GULMOHAR RESIDENCY

Details of Additions & Alterations

Flat No	306	Block no.	' D '
Flat Area	1660 sft	Type	Deluxe / Luxury
Buyer Name	V. Padmarathi / V. Venkat		
Phone No.	9030934249	Email

Changes in kitchen platform: (mark on plan)

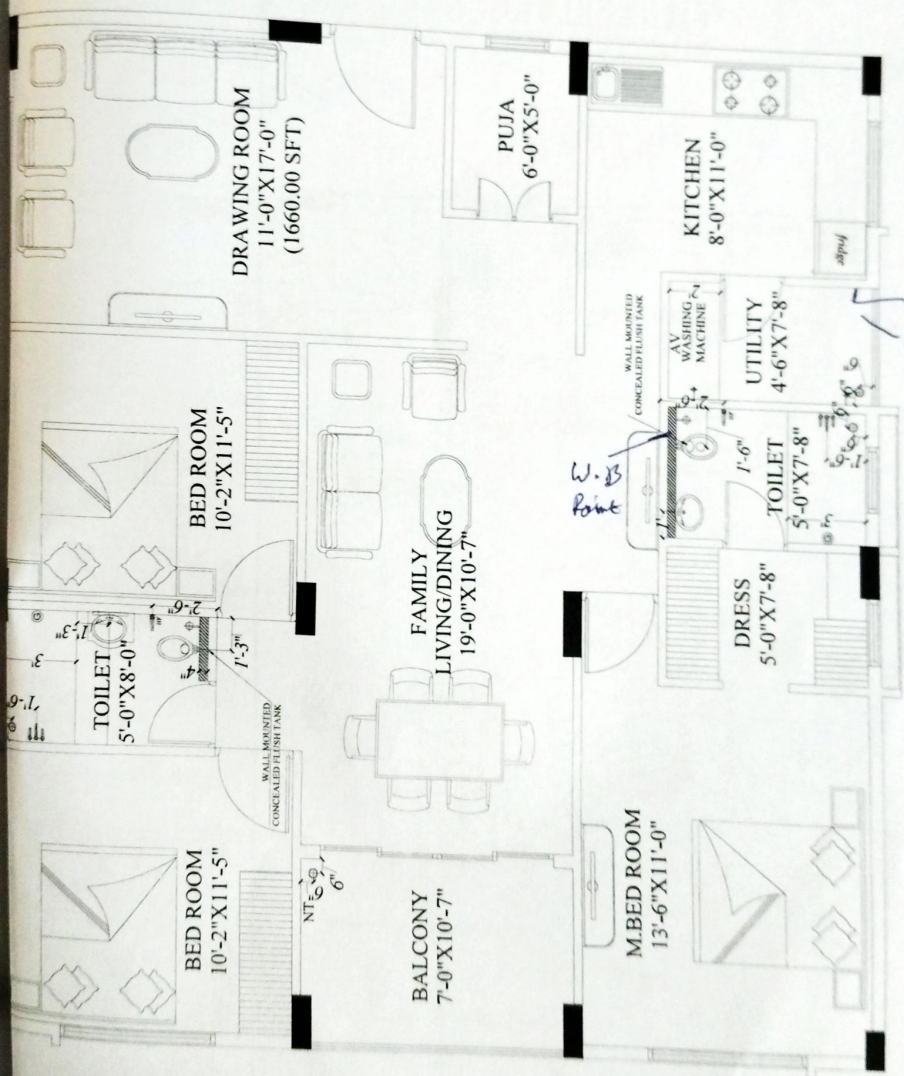
- 1) not Required RCC platform
- 2) 6" chimney not Extra at kitchen.

Description	Direction	Owners & Developer	Date	Promoted by
PLUMBING PLAN-1660 SFT (B1-TYPE)	N	Modi Reality Mallapur LLP	04/09/20	Modi Properties Pvt Ltd
		Project Name & Phase	Prepared By : Jayapratha	
		Gulmohar Residency	Approved By : Subham Modi	
			Scale :	Phase : +91-80-66335551
				N.T.S

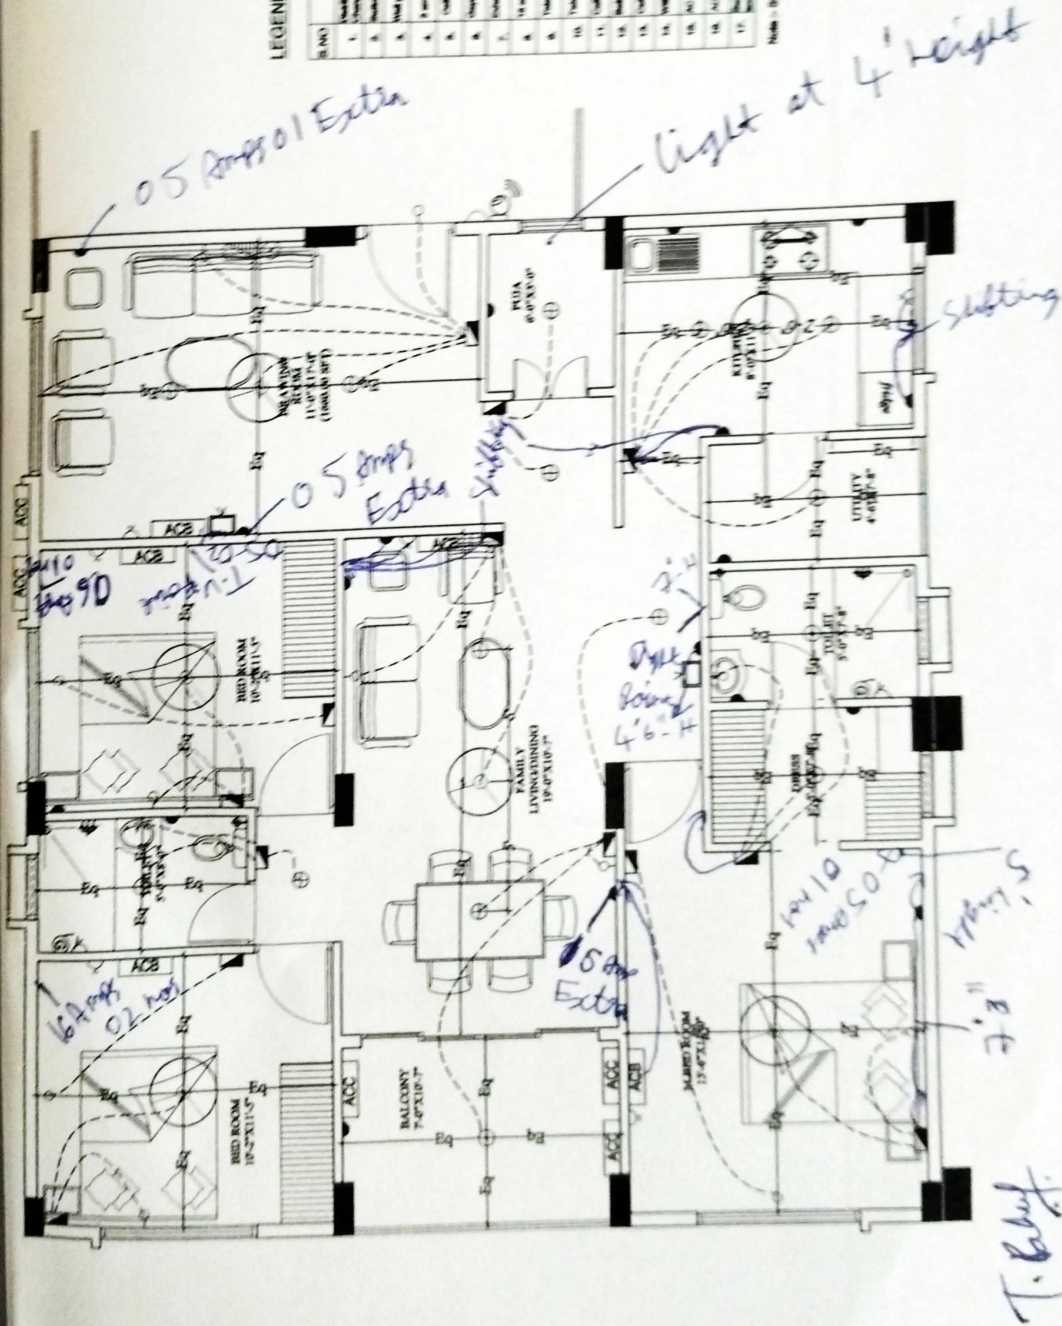
Choice of Bathroom tiles, CP fittings & Sanitary ware:

- 1) wash basin Point at Dining Wall as per Plan.
- 2) wash machine point shifting as per Plan.
Inlet & Outlet.
